SI M33 01 14
Rear Axle

June 2014
Technical Service

Delivery Stop/Service Action: Shock Absorber Rear Axle

F56 (MINI Hardtop)

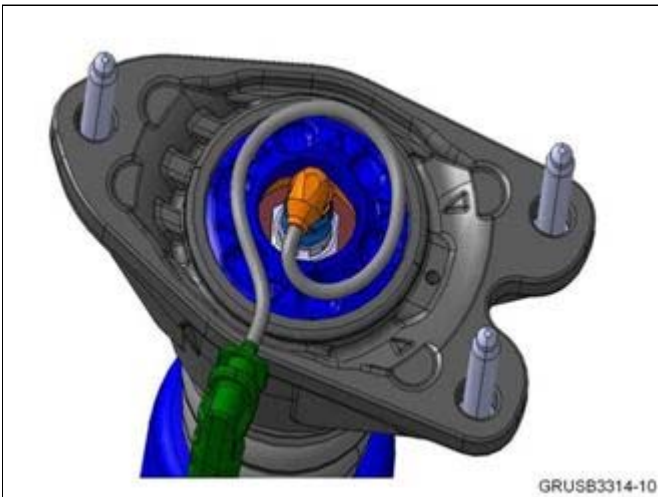
First check if a Service Action label with a code number **67** is already attached to the B-pillar.

If a code number **67** has been punched out, the Campaign has already been performed and no further action is necessary.
